Access Compliance Report

Public Rights-of-Way

Intersection ID: 10034400	Main Street: PIEDMONT_PARK_DR	Cross Street: AUDUBON_PARK_DR	Location:	N
ADA ID: E8E3BFCDC402	Ramp Type: Directional1	Initial Pass/Fail: Fail	Overall Compliance: No	Severity Score: 1.25

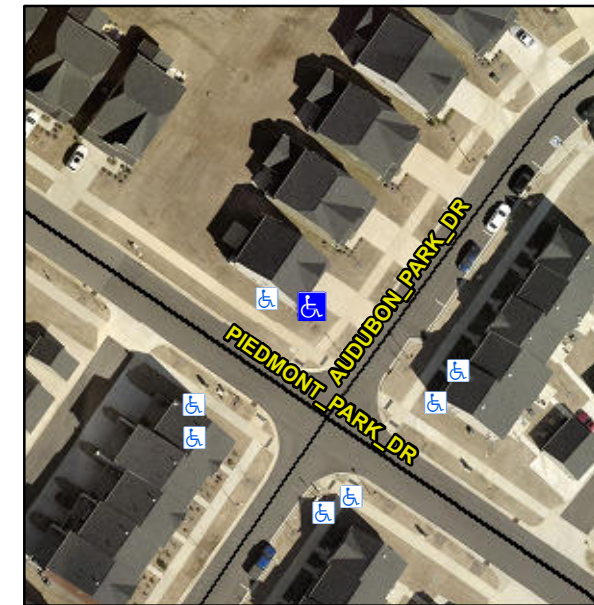
R304.5.3

Compliance	Description	Data	Compliance	Description	Data
N/A	Ramp Length (in)	104.0	N/A	Grade Break?	N/A
Yes	Ramp Width (in)	72.0	N/A	Grade Break Slope (%)	0.0
Yes	Ramp Slope (%)	2.2	N/A	Grade Break XSlope (%)	0.0
No	Ramp XSlope (%)	2.4			
N/A	Flare Type LT	N/A	N/A	Flare Type RT	N/A
N/A	Flare Slope LT (%)	N/A	N/A	Flare Slope RT (%)	0.0
N/A	Flare Traversable LT?	N/A	N/A	Flare Traversable RT?	N/A
N/A	Landing Length (in)	0.0	N/A	DWS Provided?	N/A
N/A	Landing Width (in)	0.0	N/A	DWS Contrast?	N/A
N/A	Landing Slope (%)	0.0	N/A	DWS Length (in)	N/A
N/A	Landing X Slope (%)	0.0	N/A	DWS Full Width?	N/A
N/A	Landing Curb? (Y/N)	N/A	N/A	DWS Offset LT (in)	N/A
N/A	Shared Landing?	N/A	N/A	DWS Offset RT (in)	N/A
N/A	Gutter Ponding?	0.0	N/A	Gutter Slope (%)	N/A
N/A	Gutter Lip Ht (in)	0.0	N/A	Gutter X Slope (%)	N/A
N/A	Painted X Walk1?	No		Road Slope (%)	1.9
	X Walk 1 Direction	To SE		Road X Slope (%)	0.2
	X Walk 1 Width (in)	N/A		Clear Space?	N/A

Remove & Replace Entire Ramp.
